DOCKET NO.: RCOH-1045 PATENT

Serial No.: 10/078,713

Response to Office Action of April 24, 2006

Amendments to the Drawings:

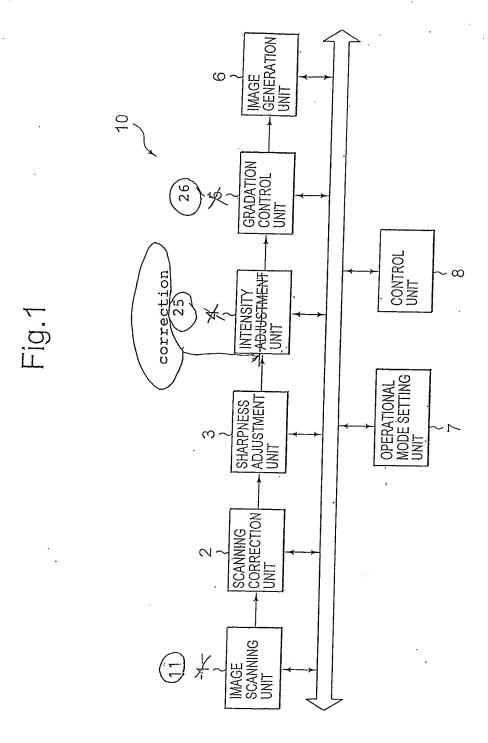
Please amend FIG. 1 with following changes:

- the reference numeral "1" is changed to "11"
- the reference numeral "4" is changed to "25"
- the reference numeral "5" is changed to "26"
- the word "ADJUSTMENT" is changed to the word "CORRECTION"

Please amend FIG. 2 by correcting the word "INTENCITY" and inserting the word "INTENSITY".

The Examiner has objected to Figure 2 for a misspelled label and some reference numerals. Accordingly, Figure 2 has been amended to correct the misspelled label. In addition, some reference numerals and the corresponding labels have been also amended in Figure 1 so that some elements in Figures 1 and 2 have the common reference numerals and label. However, since not all elements in Figure 1 correspond to those in Figure 2, not all elements in Figure 1 are amended. To accommodate the drawing amendments, the corresponding descriptions have been also amended in the specification.

Fig.5

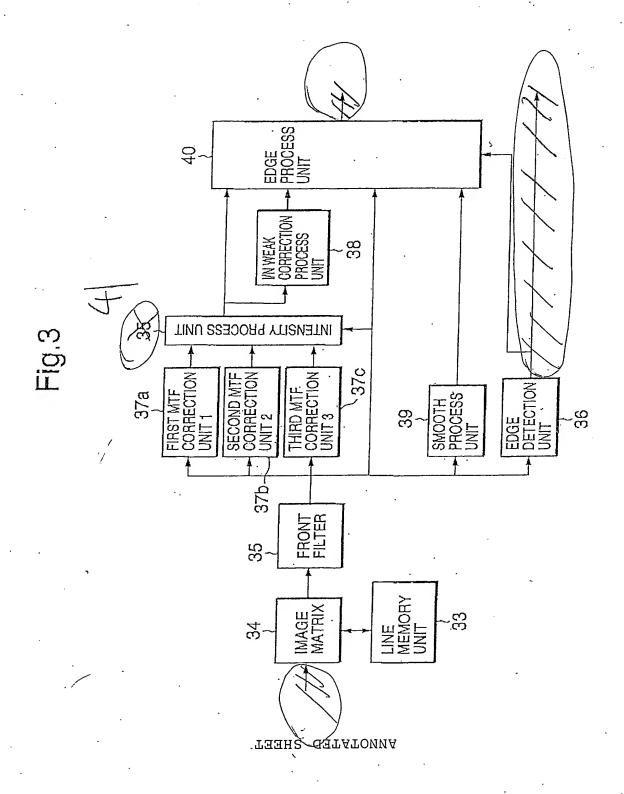
Please amend FIG. 5 with the following changes:

- the word "EDEGE" should be changed to the word "EDGE"
- words "IMAGE DATA" should be changed to words "EDGE INFO"

The Examiner has objected to Figure 5 since it includes a misspelled word and inconsistency. That is, Figure 5 shows "IMAGE DATA" while the corresponding description at lines 21, 22 on page 9 discloses that "[b]ased upon the edge information, one of two intensity correction tables T1 and T2 is selected." Accordingly, the misspelled word is amended, and the consistent label now reads "Edge Info."
